Access Compliance Report

Public Rights-of-Way

Intersection ID: 13184	Main Street: SUMMIT_AV	Cross Street: S_MINT_ST	Location: NE
ADA ID: 929F1DB42BA7	Ramp Type: PerpDiag	Initial Pass/Fail: Fail	Overall Compliance: No
		Severity Score: 8.75

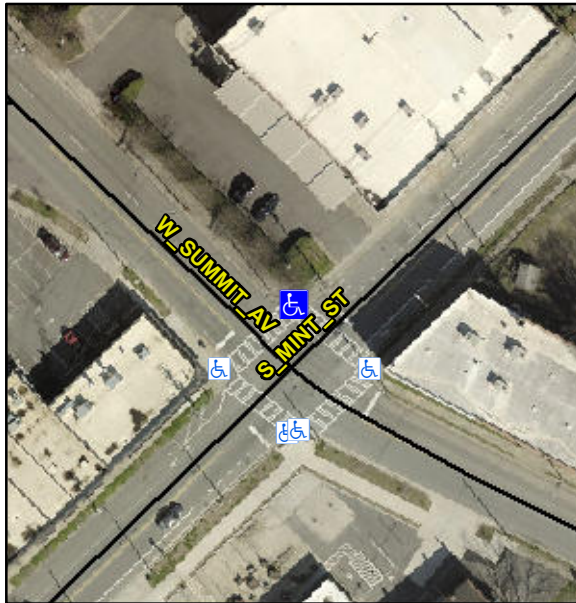
R304.5.1

Compliance	Description	Data	Compliance	Description	Data
N/A	Ramp Length (in)	76.0	Yes	Ramp Slope (%)	6.9
No	Ramp Width (in)	44.0	Yes	Ramp XSlope (%)	1.0
N/A	Flare Type LT	N/A	N/A	Flare Type RT	N/A
N/A	Flare Slope LT (%)	N/A	N/A	Flare Slope RT (%)	N/A
N/A	Flare Traversable LT?	N/A	N/A	Flare Traversable RT?	N/A
N/A	Landing Length (in)	N/A	N/A	DWS Provided?	N/A
N/A	Landing Width (in)	N/A	N/A	DWS Contrast?	N/A
N/A	Landing Slope (%)	N/A	N/A	DWS Length (in)	N/A
N/A	Landing X Slope (%)	N/A	N/A	DWS Full Width?	N/A
N/A	Landing Curb? (Y/N)	N/A	N/A	DWS Offset (in)	N/A
N/A	Shared Landing?	N/A			
N/A	Gutter Ponding?	N/A	N/A	Gutter Slope (%)	N/A
N/A	Gutter Lip Ht (in)	N/A	N/A	Gutter X Slope (%)	N/A
N/A	Painted X Walk1?	Yes	N/A	Painted X Walk2?	Yes
	X Walk 1 Direction	To SW		X Walk 2 Direction	To SE
N/A	X Walk 1 Width (in)	111.0	N/A	X Walk 2 Width (in)	108.0
	X Walk 1 Slope (%)	3.6		X Walk 2 Slope (%)	4.8
	X Walk 1 X Slope (%)	6.0		X Walk 2 X Slope (%)	2.8

Remove & Replace Curb Ramp With Two New Directional Ramps or Equivalent.
